## SERVICE BULLETIN

**APPLICABILITY:** 2016MY WRX and STI Models **NUMBER:** 07-99-15  
**SUBJECT:** Reprogramming File Availability for Keyless Buzzer Volume **DATE:** 10/26/15

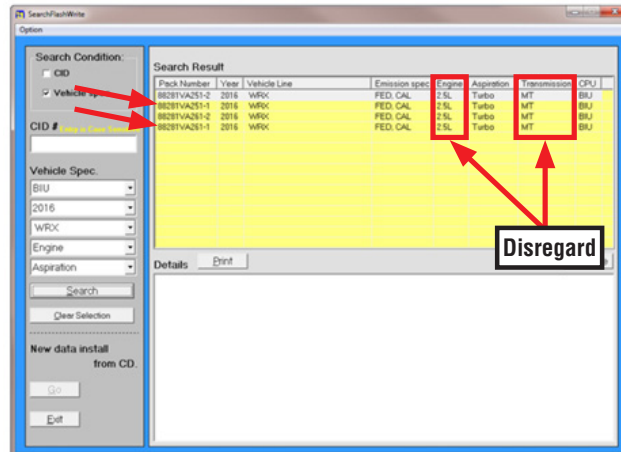
This bulletin is the first for BIU reprogramming. When performing this update, you will notice some small differences in the Flashwrite screens. First, when entering your Vehicle spec. search criteria, BIU has been added to the CPU selection list.

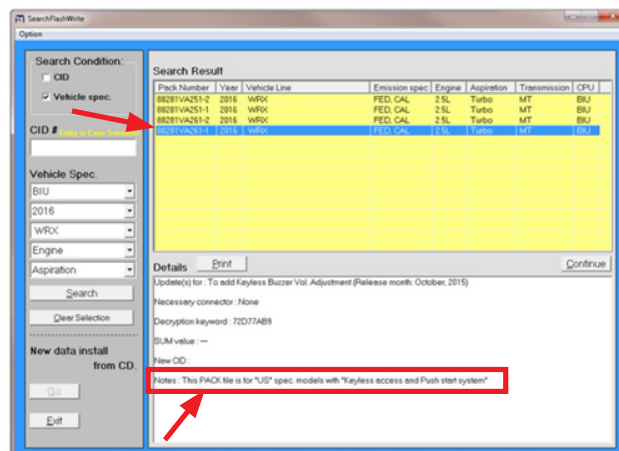
- After making your selections and clicking on Search, the Result will list 4 available Pack files:

**IMPORTANT NOTE:** Currently, 2 of the 4 files listed for this Search Result are for Canada-spec. vehicles and 2 are for US-spec. In addition, for this update, Engine and Transmission types can be disregarded.

- The 2 files to be used for US-spec vehicles are 88281VA251-1.pak and 88281VA261-1.pak. Pay close attention to the applicability (with or without Keyless access) listed in the “Notes:” listed for each file in the details area of the Search Result screen before making your selection. If you attempt to install the wrong file for the vehicle, an error message will be displayed on the SSM.

Control Switch  
 1) Up (select)  
 2) ENTER (push)  
 3) Down (select)

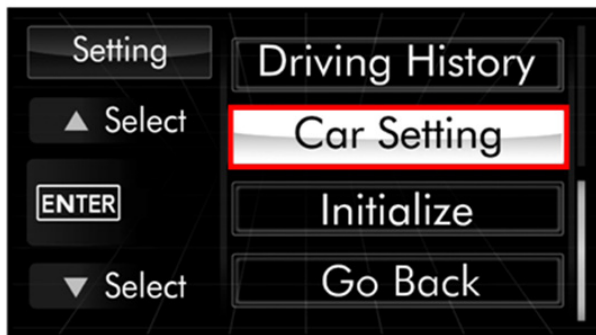
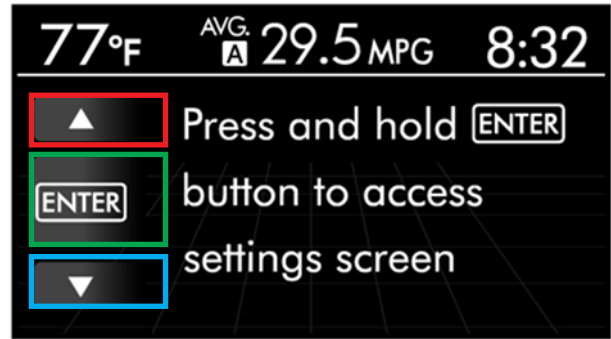
- After reprogramming is done, complete the procedure by confirming proper MFD operation following the screen shot sequence below. Push Up or Down on the ENTER button to scroll then push the ENTER button in to make (enter) your selection.

- Push Up or Down on the ENTER button to adjust the volume then push the Enter button in to select and save the desired setting.
